DOCUMENT CHANGE REQUEST

DCR number 296

Title: Switches Thermostatic Bimetallic SPDT Opening Contact

Number: 3702/001

FIGURE 2 - PHYSICAL DIMENSIONS**FIGURE 2(a) - VARIANT 01 (Note 3)****FIGURE 2(b) - VARIANT 02 (Note 3)****NOTES**

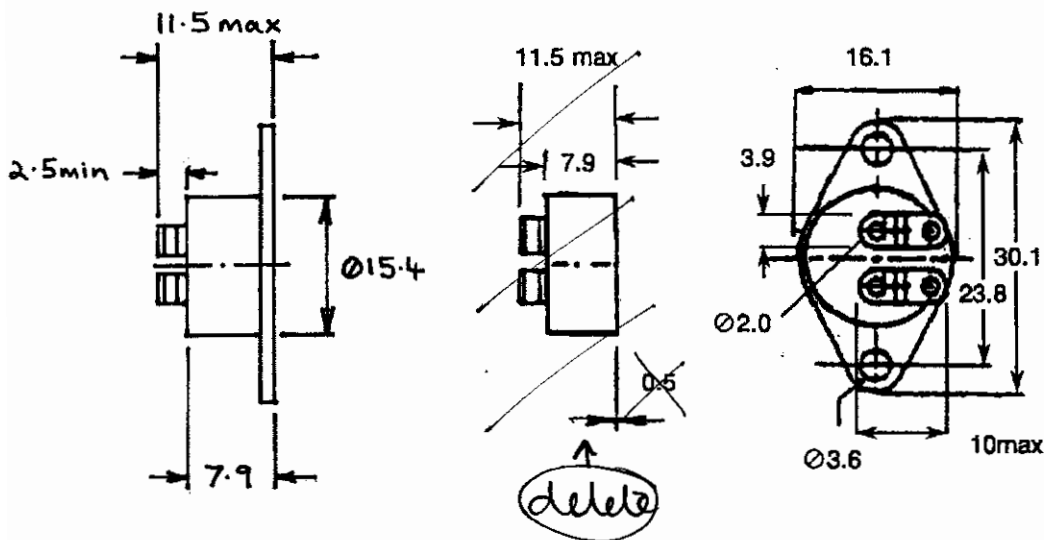
- Drawing and Dimension Table according to general ESCC format
- Drawing for variant 02 was wrong
- The dimension B for variant 03 was missing

Attachments:
DCR296_Attachment_8Feb07.pdf, DCR_Figures_2.doc, null
Modifications:
See attached modified new drawings for Figures 2(b) and 2(c) including: for Figure 2(b) - delete flange thickness (0.5); add terminal height (2.5min) and body diameter (15.4) for Figure 2(c) - delete stud base thickness (1.5); add terminal height (2.5min) and total body thickness (8.2) Add new note 3 to titles of Figures 2(a), 2(b) 2(c) Note 3. Dimensions applicable to the body and terminals of variant 01 shall also apply to variants 02 and 03. Justification Drawing for variant 02 was wrong (flange was missing). Total body thickness was missing for variant 03. Clarification that the body and terminal dimensions are the same for variants 01, 02 and 03.
Approval signature:

1. All dimensions are in millimetres.
2. Tolerance $\pm 0.1\text{mm}$, unless otherwise specified.
3. Dimensions applicable to the body terminals of variant 01 shall also apply to variant 02 and 03

FIGURE 2 - PHYSICAL DIMENSIONS (CONTINUED)**FIGURE 2(c) - VARIANT 03 (Note 3)****FIGURE 2(d) - VARIANT 04**

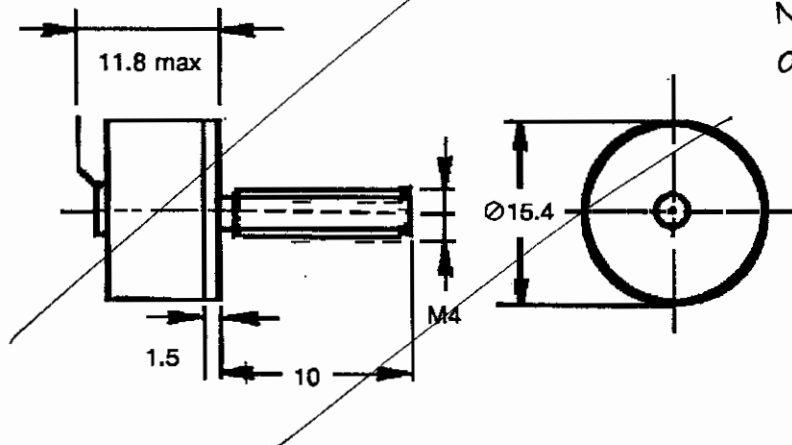
Note:
delete fig 2(d)
per DCR 282
